ADDENDUM No. 1

Date **Friday April 10, 2026**

Project: **CommuniHealth Monroe
1205 Louisville Avenue
Monroe, LA 71201**

A4.02
Date: MARCH 2026
Project No: 24-BC0033
File Name:
DESCRIPTION:
BUILDING SECTIONS & DETAILS

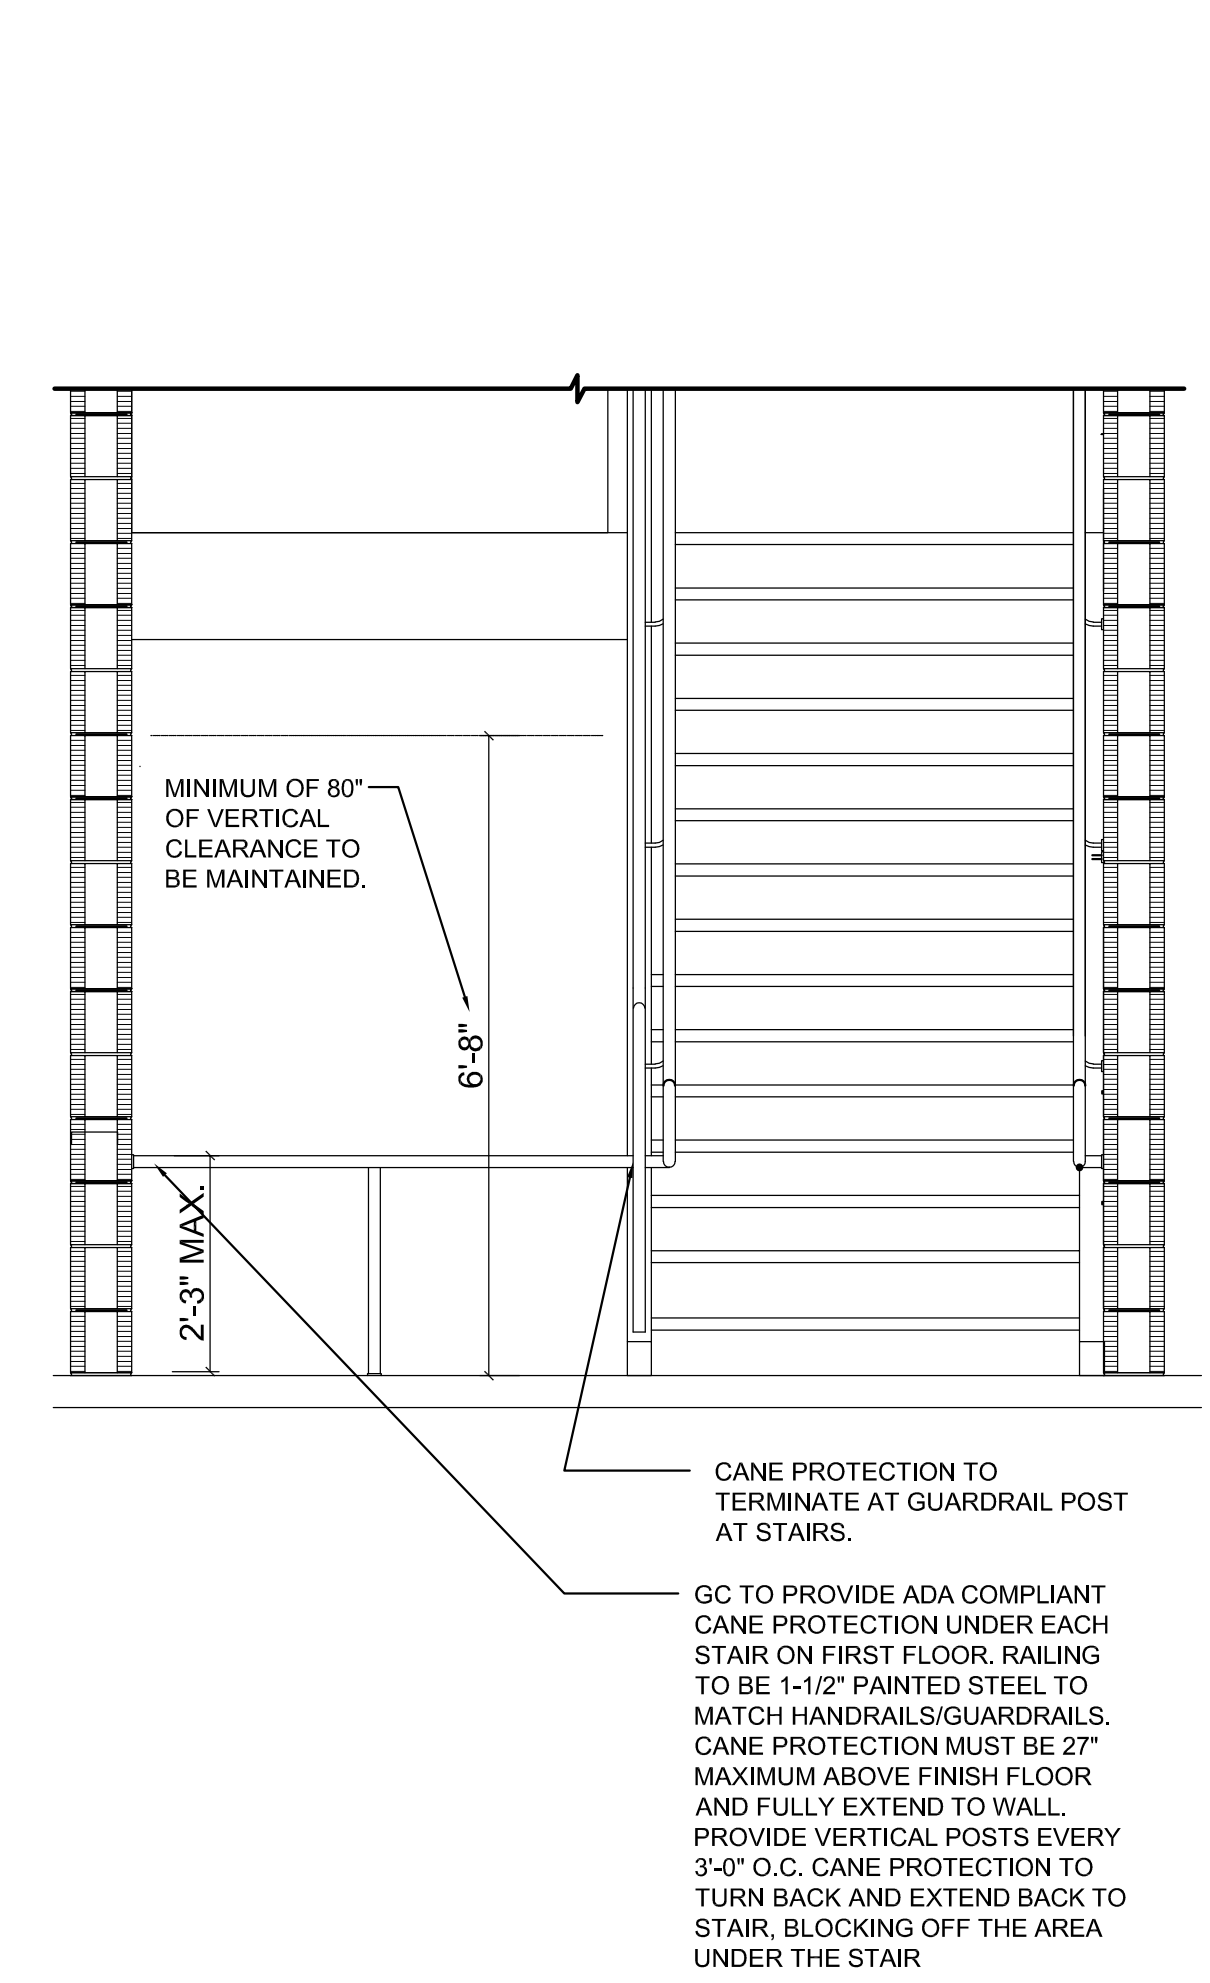
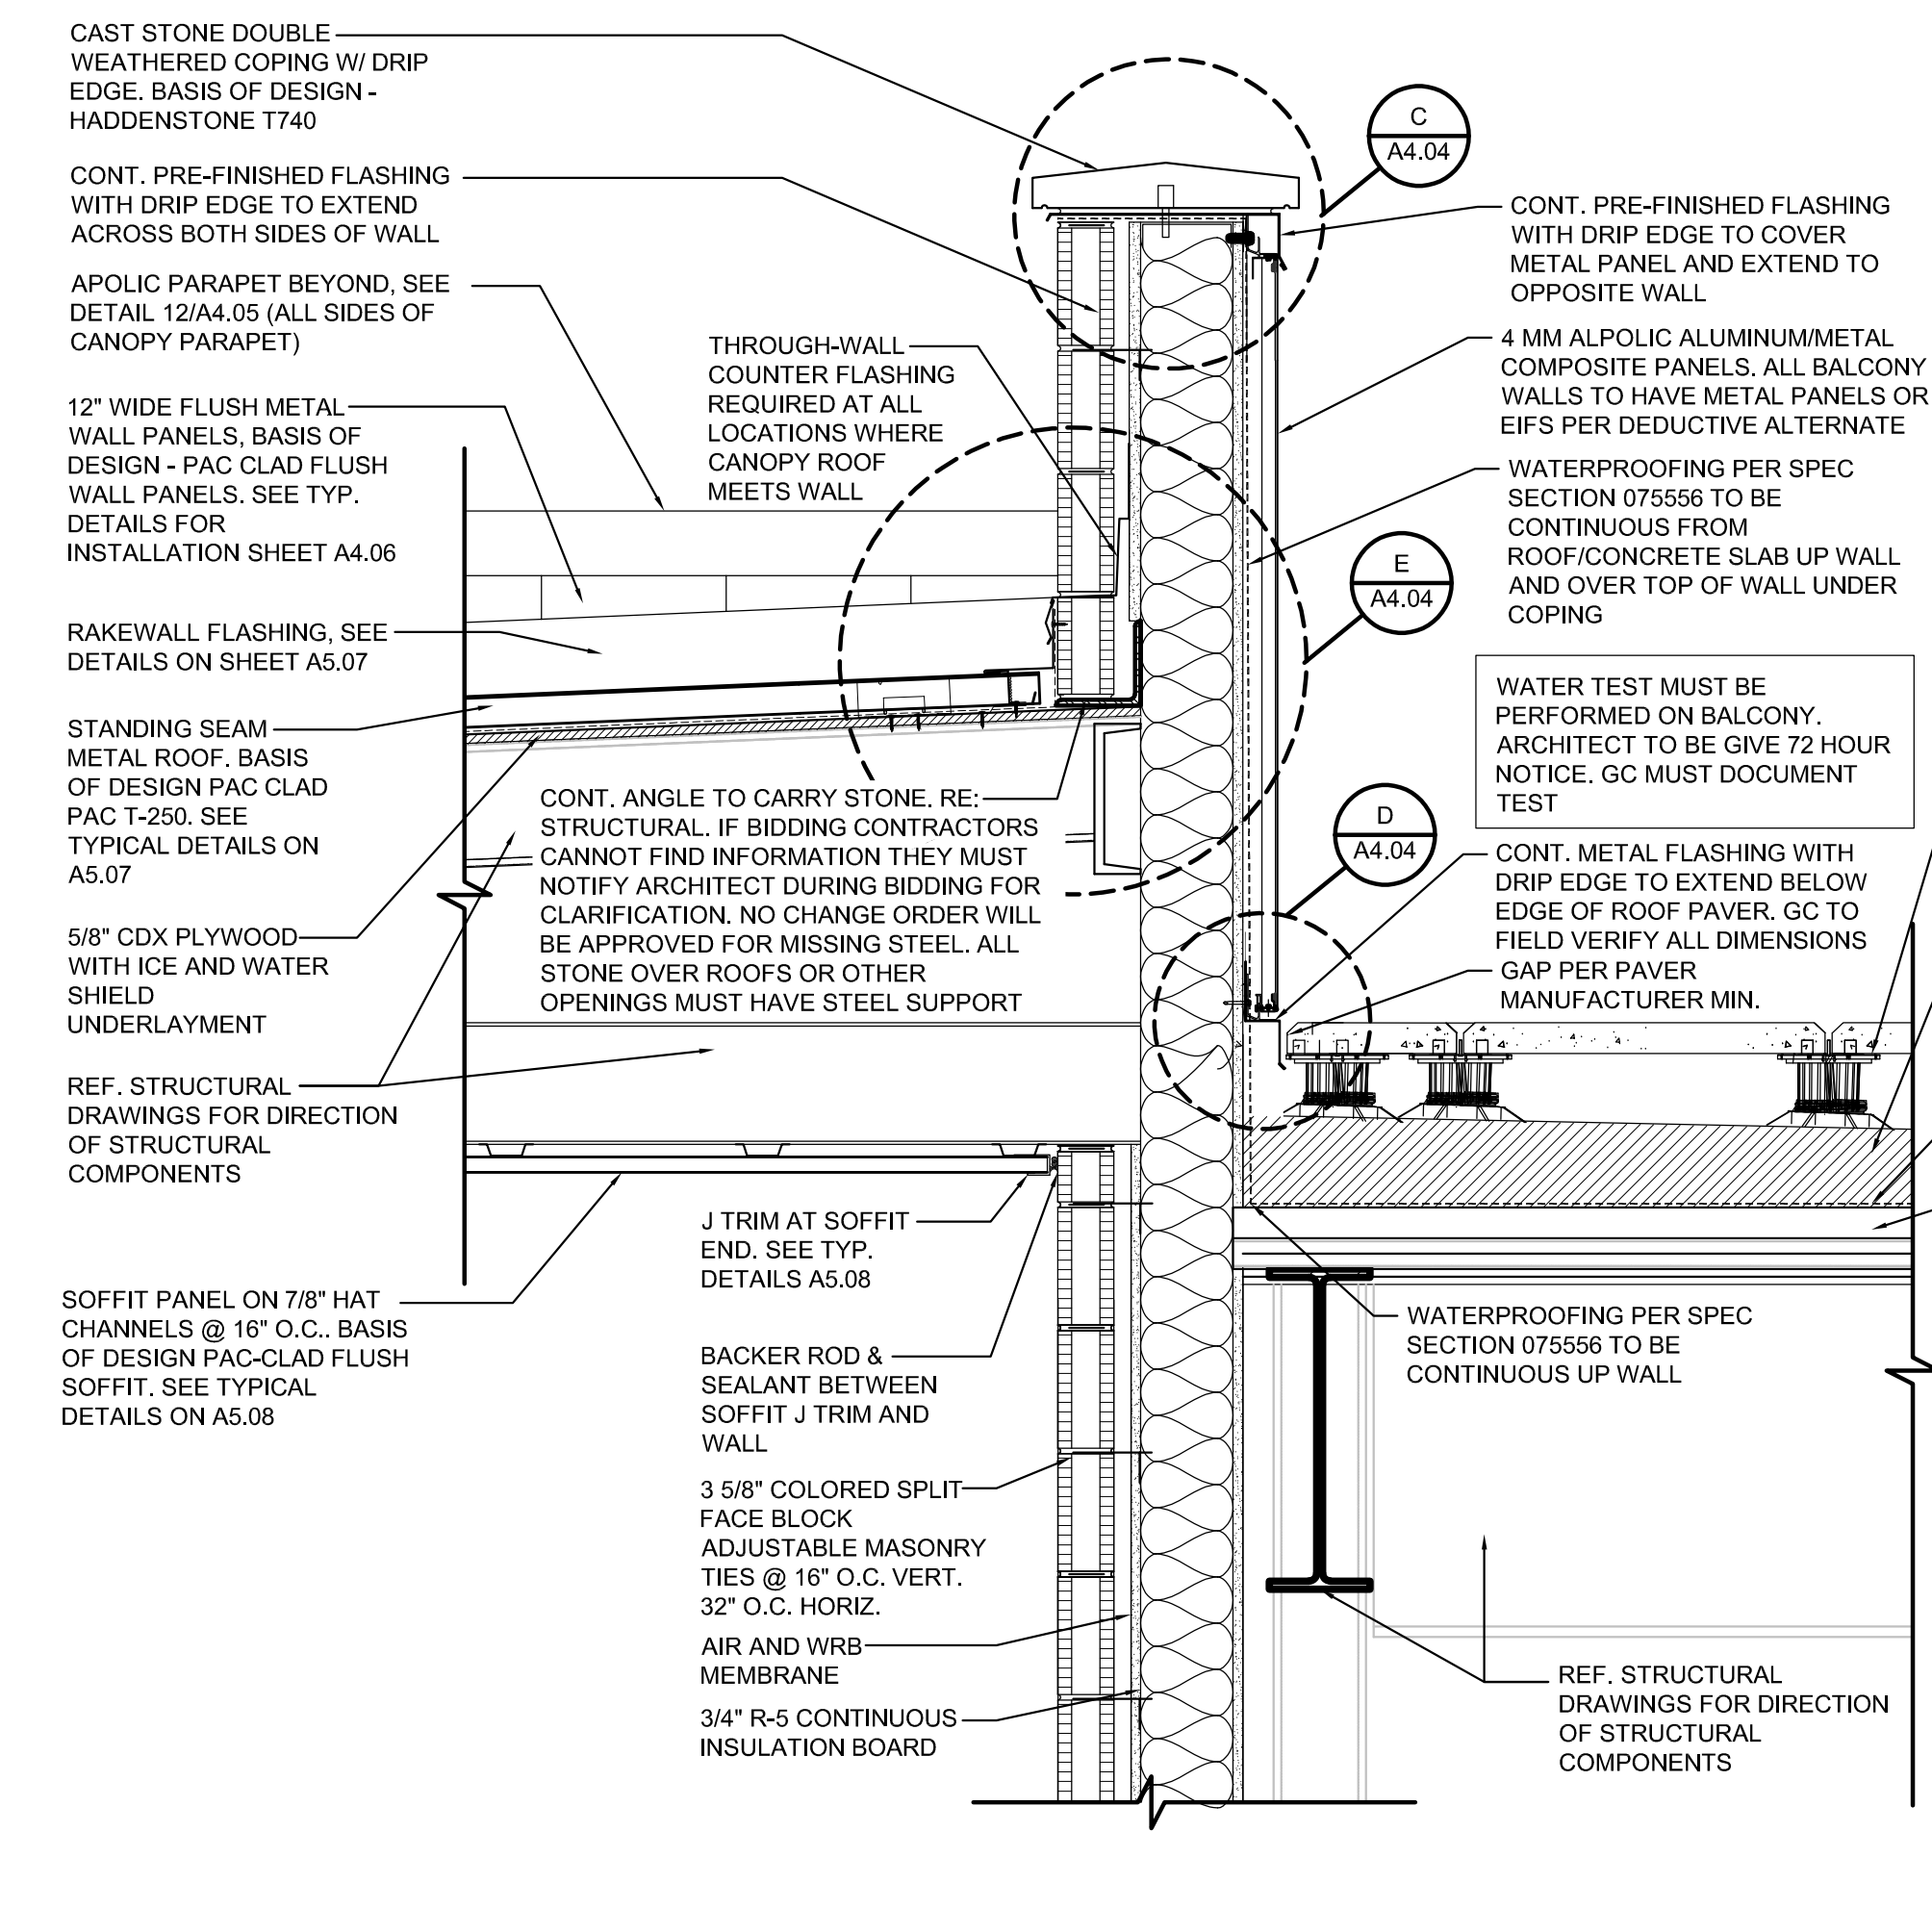
18. Balcony Columns – the intention is for the CMU around the columns to stop above the tile tech paver system. The CMU will have to be supported by a steel angle sized to support the CMU and tied back into the structural framing. The column framing will extend down to concrete deck and will receive the same wall sheathing and waterproofing like all exterior walls. The waterproofing and protection course at the balcony will extend up the structural framing at the columns similar to shown on detail 3/A4.02.
